{ Denotes changes to ADD. 98 - 10/15/76 CO ADD. 98 - 5/5/77

H-1 VIADUCT (WB)

INDEX TO DRAWINGS
ESTIMATED QUANTITIES

KEEHI INTERCHANGE
F.A.I. PROJ. NO. I-HI-1 (130): 17

SECTION  AT GIRDER SHELF
NTS

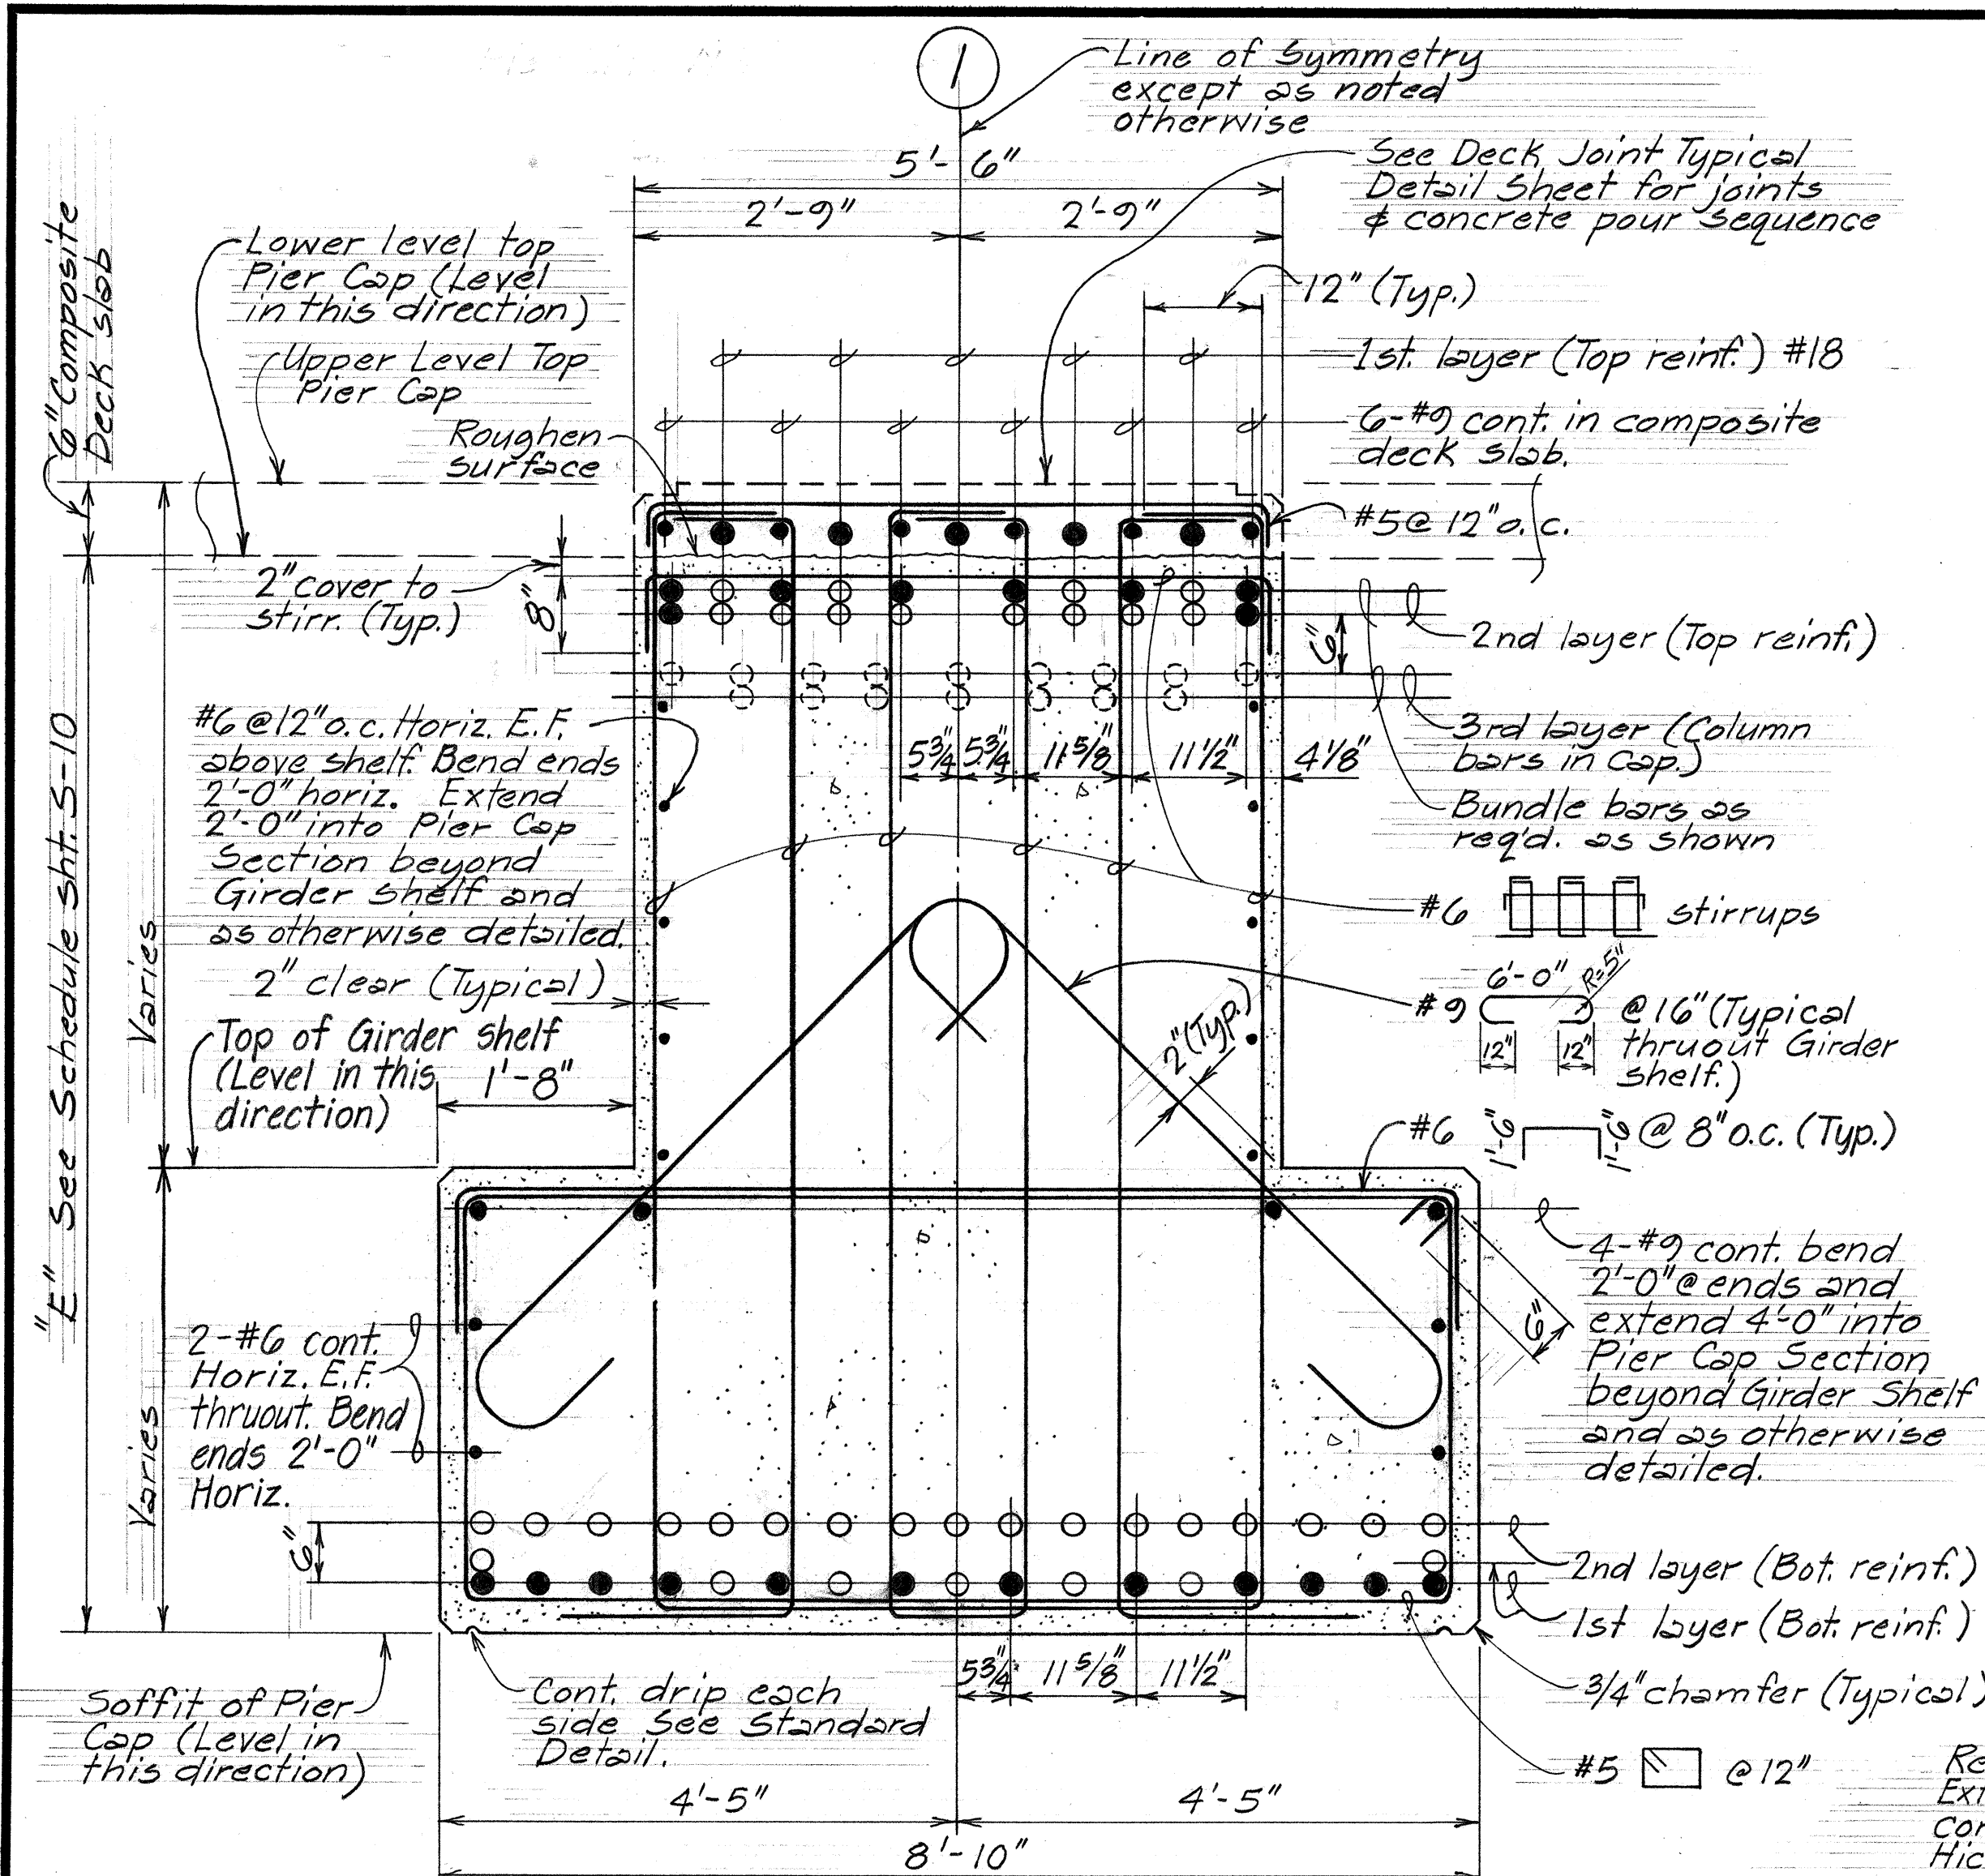
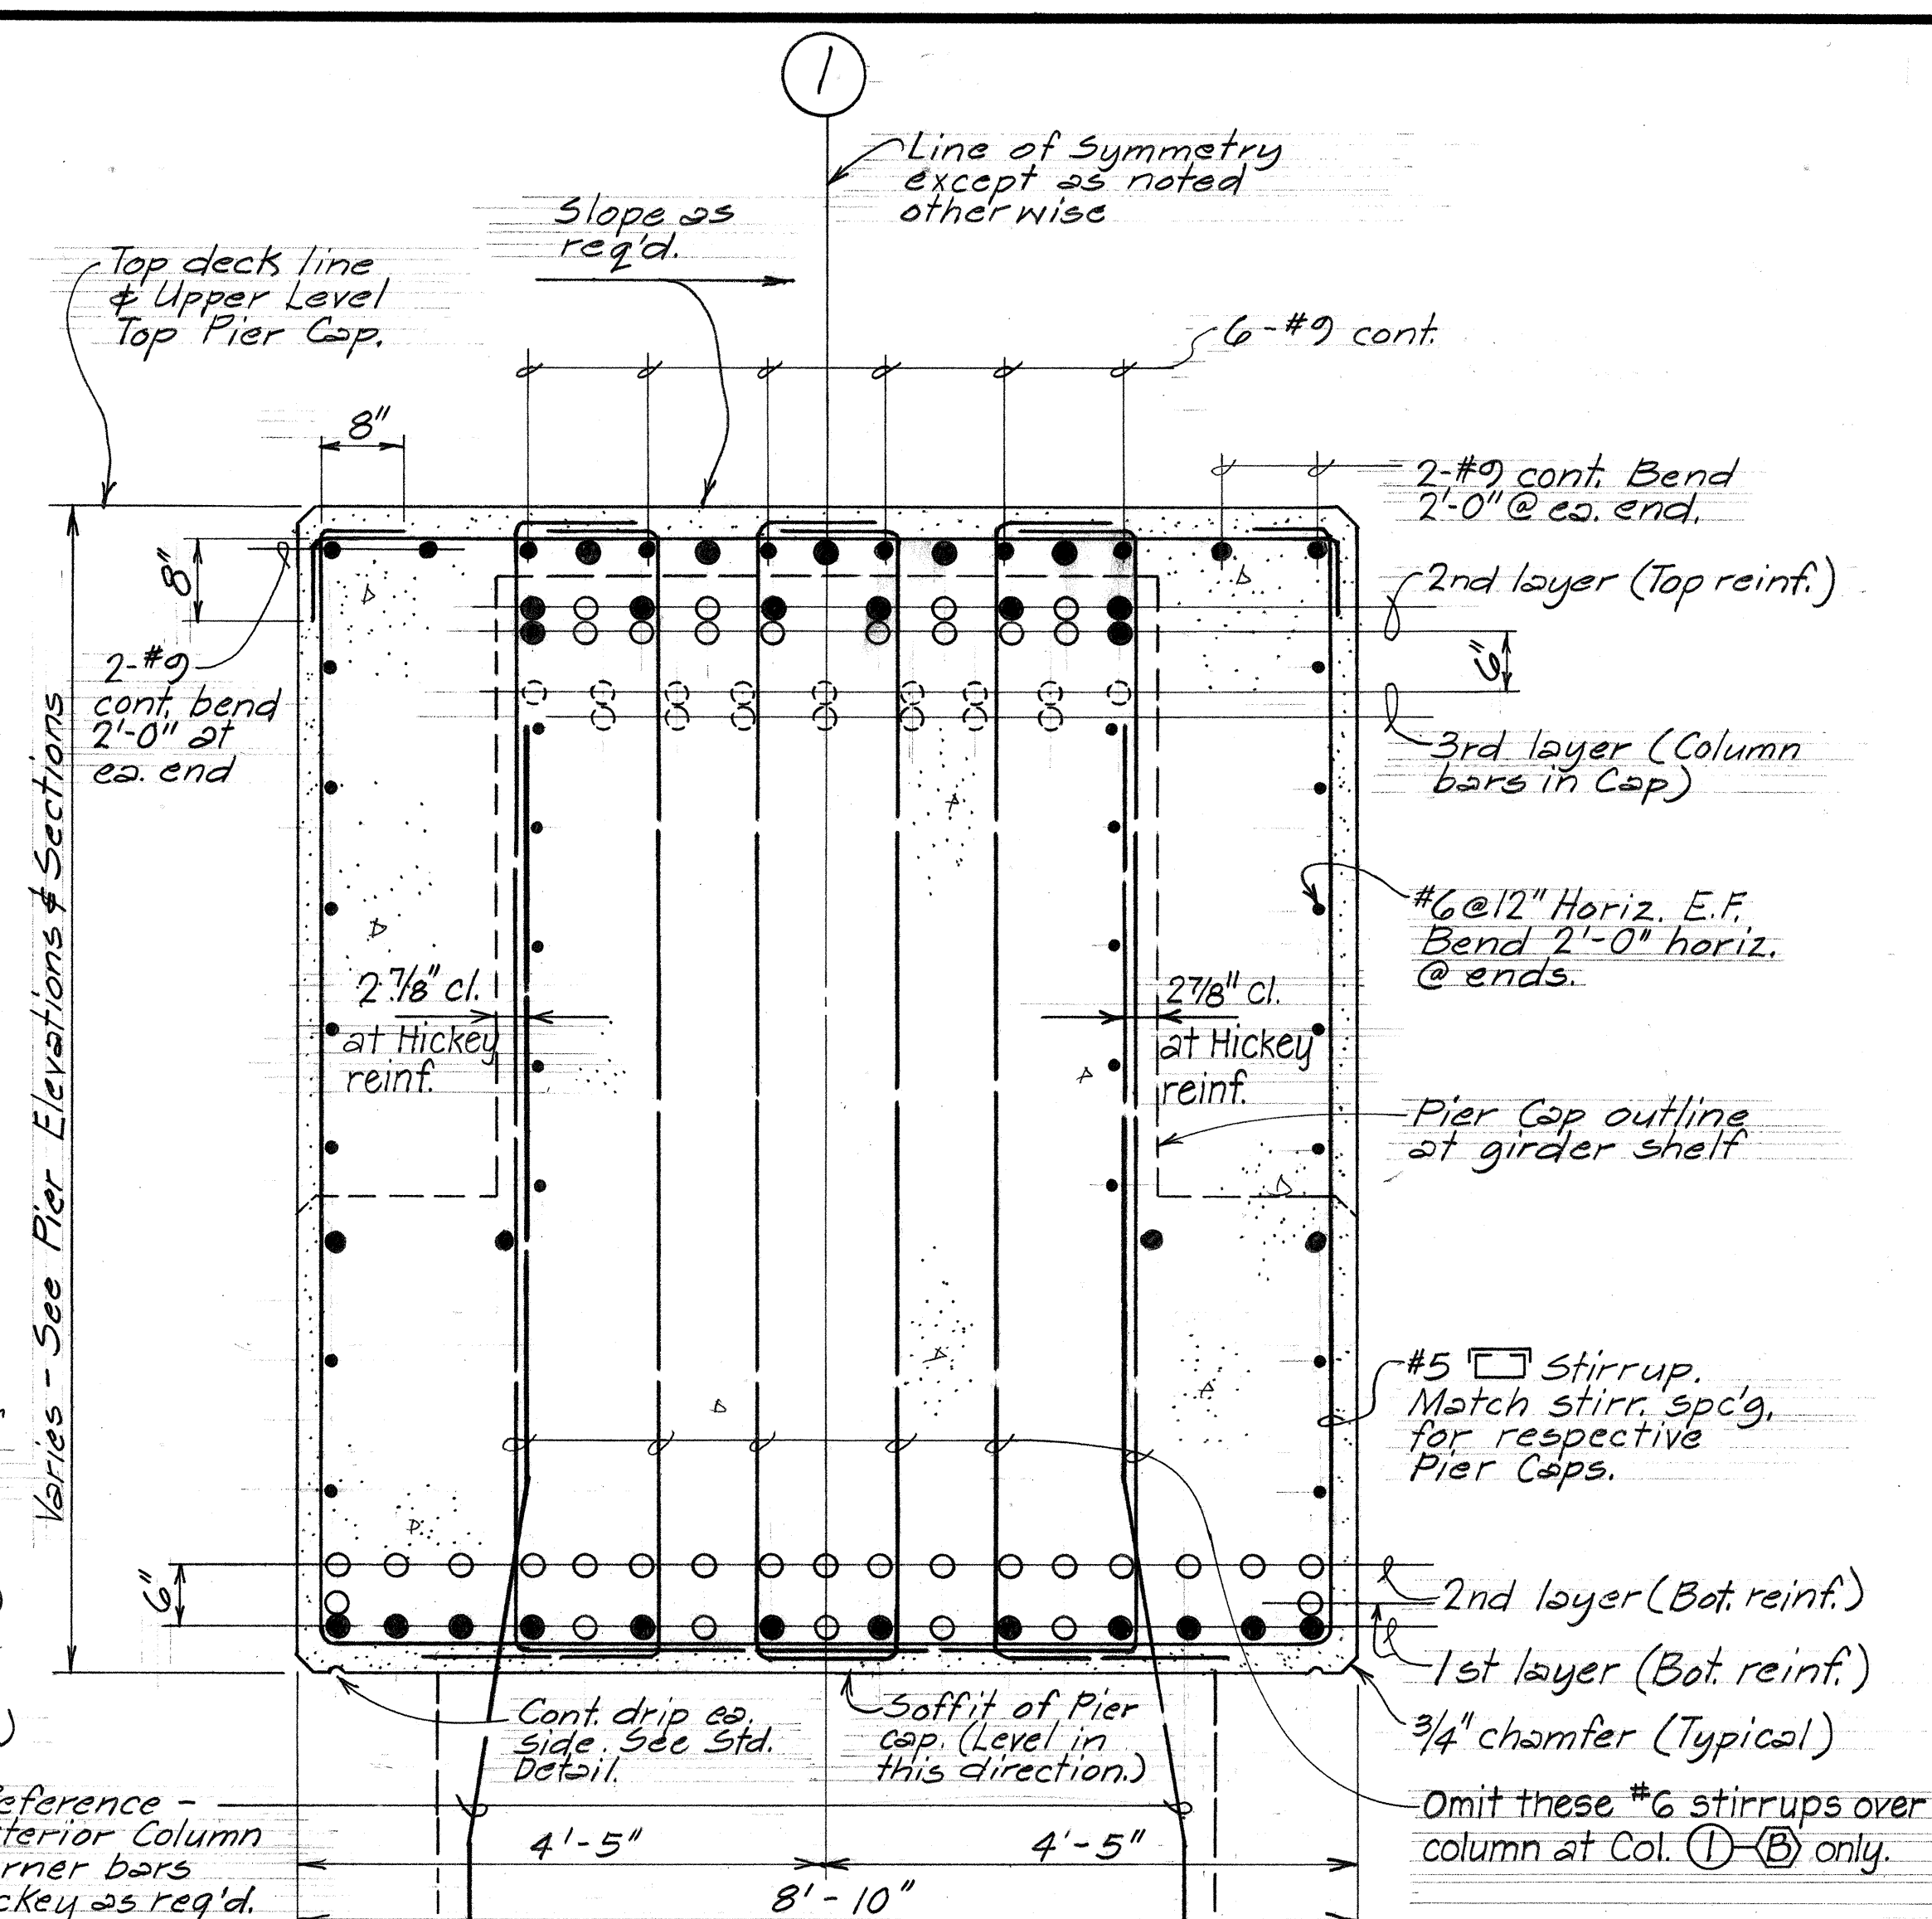
5/5/77	Revised Pier No.1 sections & details. Revised deck drain downspout. Sheet added to contract plan set for additional details required on Sht. # C.O. 113
DATE	REVISION
